ATKINS ENGINEERS

FEBRUARY 16, 2007

Project Name : Hamptons South
Address : 20201 East Country Club Drive
City : Aventura
State : Florida Zip: 33180
Category : Condominium
Date of Inspection : September - October 2006

4. Architectural/Structural Observations

**03-01 Concrete Member Cracks****Observation**

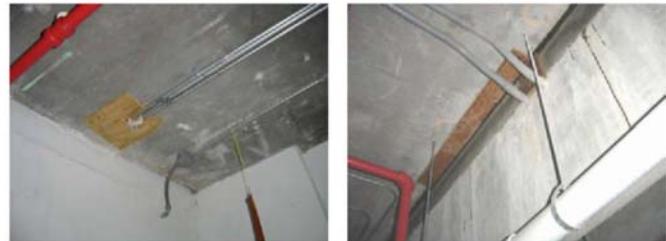
Concrete beams, columns, walls and slabs are cracked/spalling. See Appendix for further information.

Further investigation is required to determine the cause and extent of the reported condition and any remediation required. See Appendix for further information.

07-04 Roof Tiles**Observation**

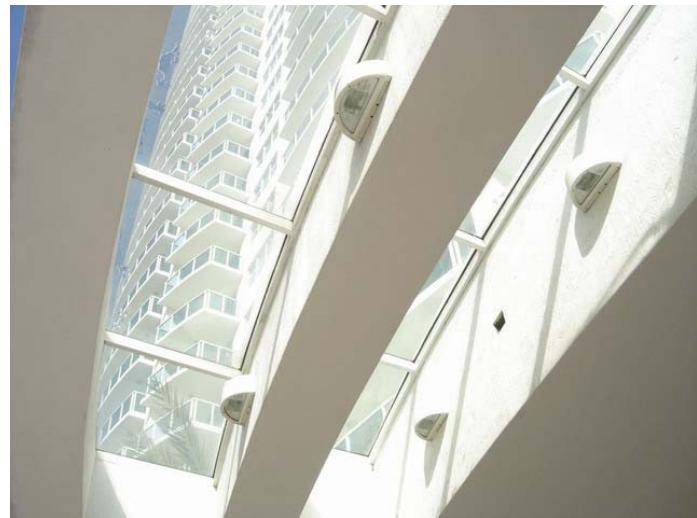
There are missing and/or broken roof tiles.

Remove and replace damaged roof tile.

26-03 Electrical Installation Methods*Observation*

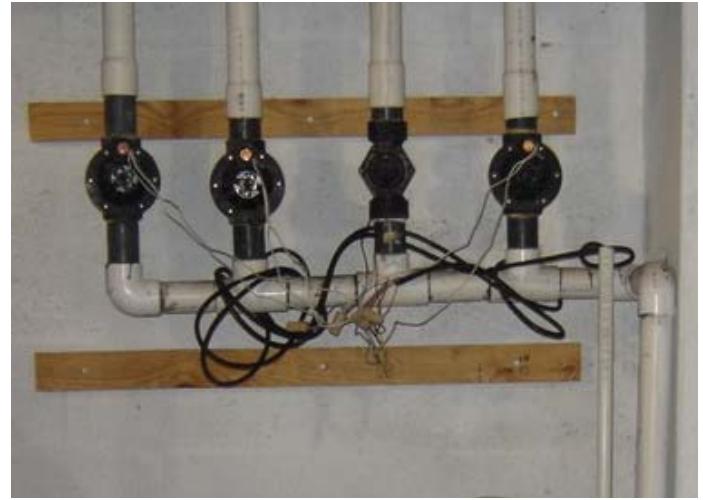
Irrigation zone control valve installation is not properly secured.

Terminate and secure wiring. Remove excess wiring.

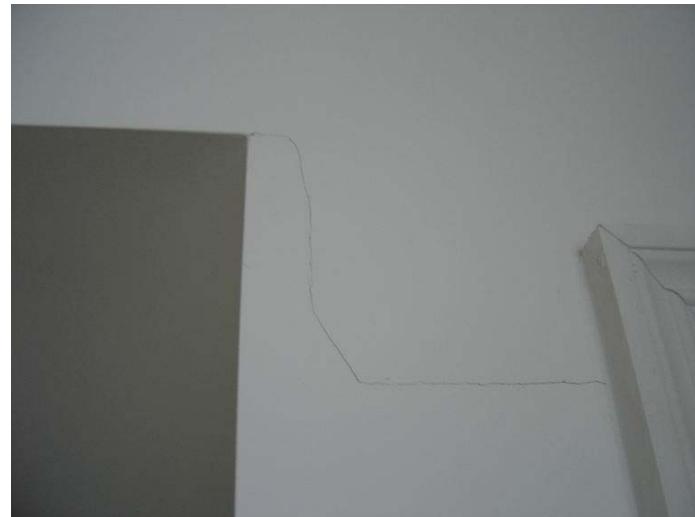
Cracks, gouges, warping, screws, holes and unfinished areas were observed in the drywall.

Remove damaged materials, cut square, patch, sand and finish to match existing.

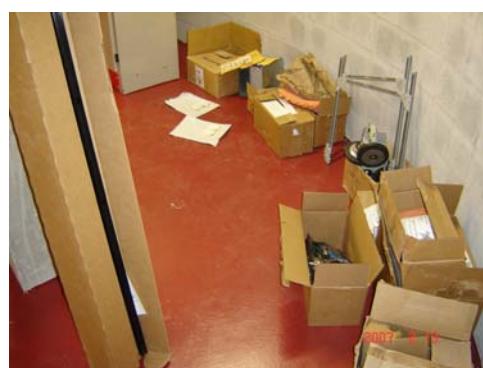
VIEW OF TEMPORARY JUMPER WIRES THAT MUST BE REMOVED FROM
BUILDING TO PREVENT UNSAFE OPERATION OF ELEVATORS.

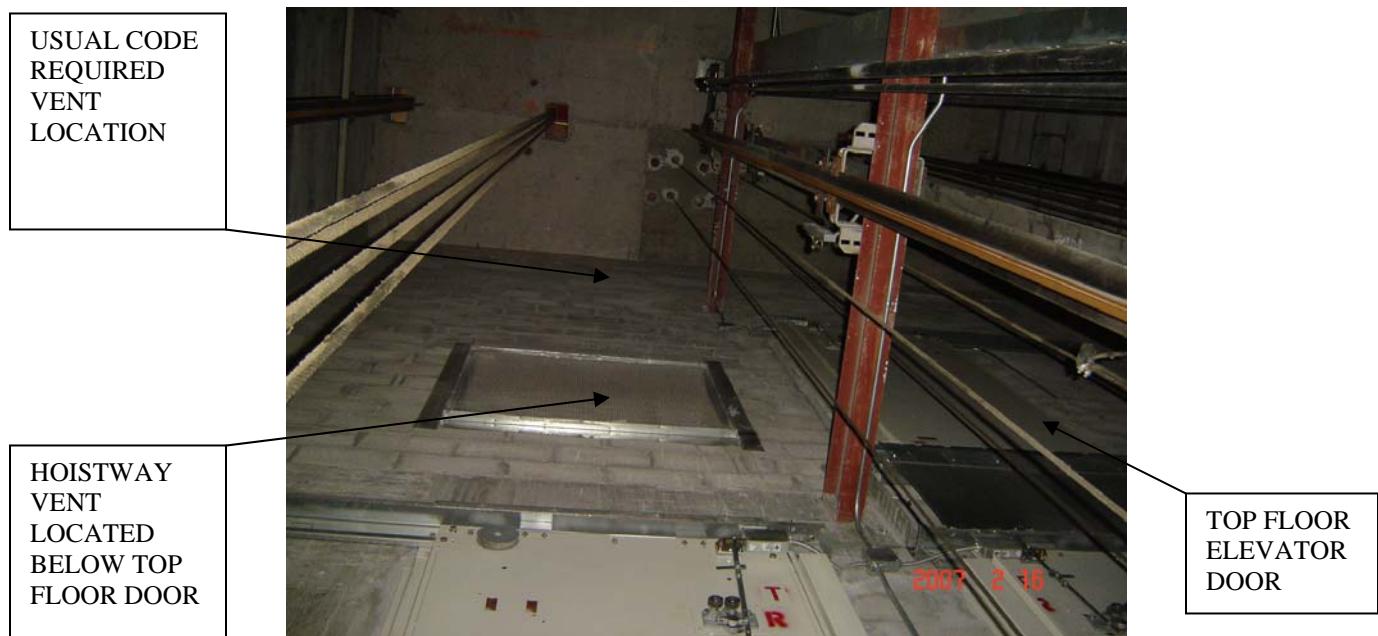
VIEW OF HIGH RISE ELEVATOR PE6 COMPENSATION CABLE SHOWING HOW CABLE IS NOT IN CENTER OF FOUR GUIDE ROLLERS.

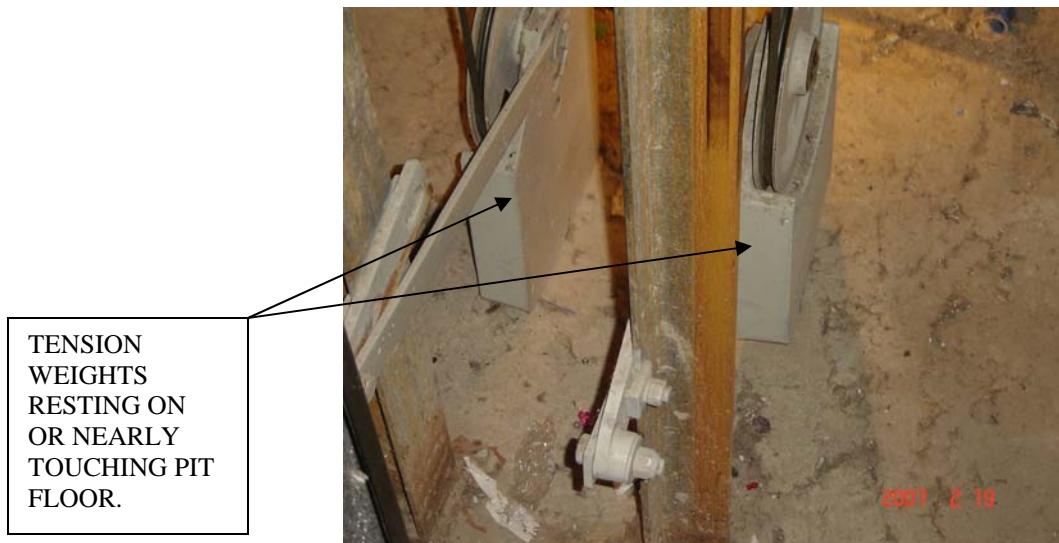
VIEW OF TYPICAL HIGH RISE ELEVATOR HOISTWAY VENT. NOTE LOCATION NEXT TO ROOF FLOOR ELEVATOR DOOR INSTEAD OF CODE REQUIRED LOCATION AT TOP OR HOISTWAY JUST UNDER MACHINE ROOM SLAB. MUST BE INVESTIGATED FOR CONFORMANCE/APPROVAL.
